AMENDMENTS TO DRAWINGS

REMARKS

Annotated Sheet Showing Changes
2/3

Figure 2A

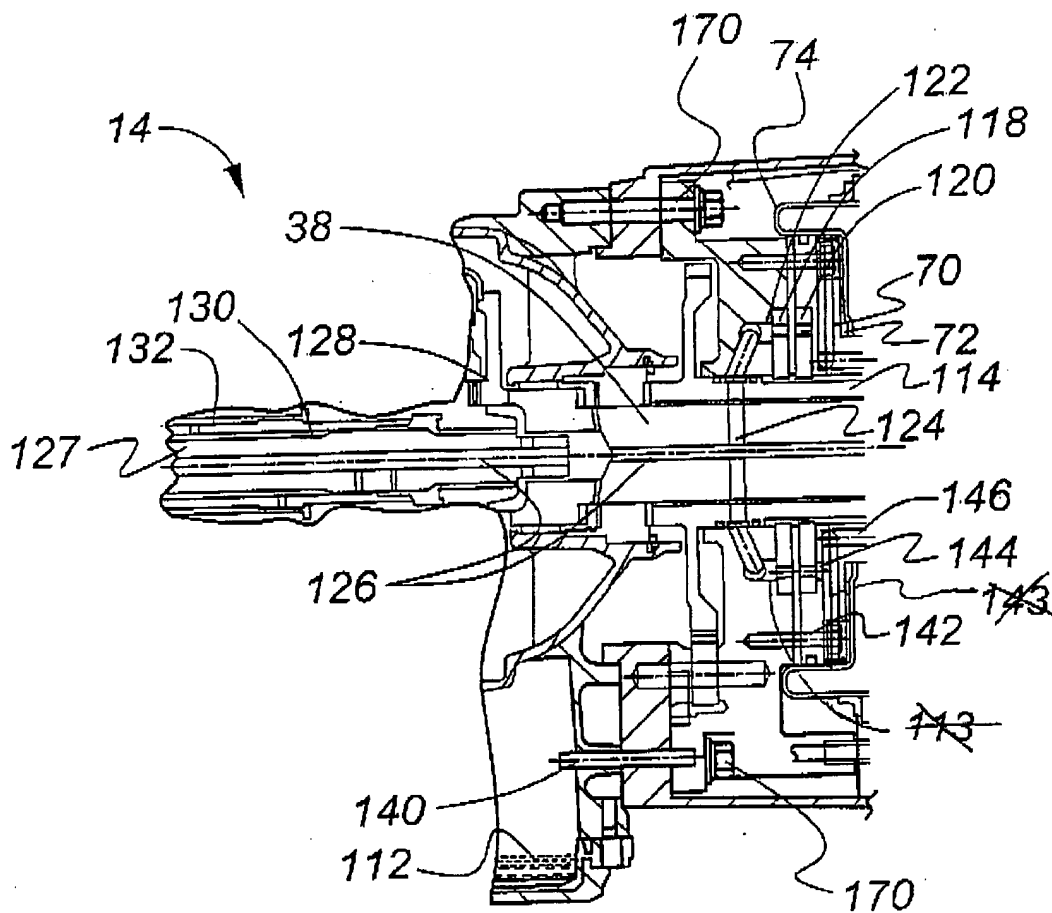
A Replacement Sheet for Page 2/3, Figure 2A, which is attached to this amendment, removes the changes of the prior amendment and restores Figure 2A to its condition when originally filed. Specifically reference numbers 113 and 143 have been removed from Figure 2A, thereby removing the inlet of scavenge pump 118 identified by reference number "113" and the radial passage, reference number "143."

An Annotated Sheets Showing Changes to Figure 2A on page 2/3 is enclosed. The amendment to the drawing enters no new matter; instead, it restores Figure 2A to its condition when originally filed.

The drawings stand objected to under 37 CFR 1.83(a). The first and second lubrication circuits recited in the claims are illustrated in the drawings, as the drawings were originally filed, with reference numbers and lead lines pointing to the elements of both lubrication circuits. Reference numbers 113 and 143, which were added to the drawings in a prior amendment, have been removed from Figure 2A by this amendment, thereby placing Figure 2A in the same condition as when the application was originally filed. No new matter has been entered in the drawings of the application. The basis for the objection to the drawings has been removed by these amendments to the drawings.
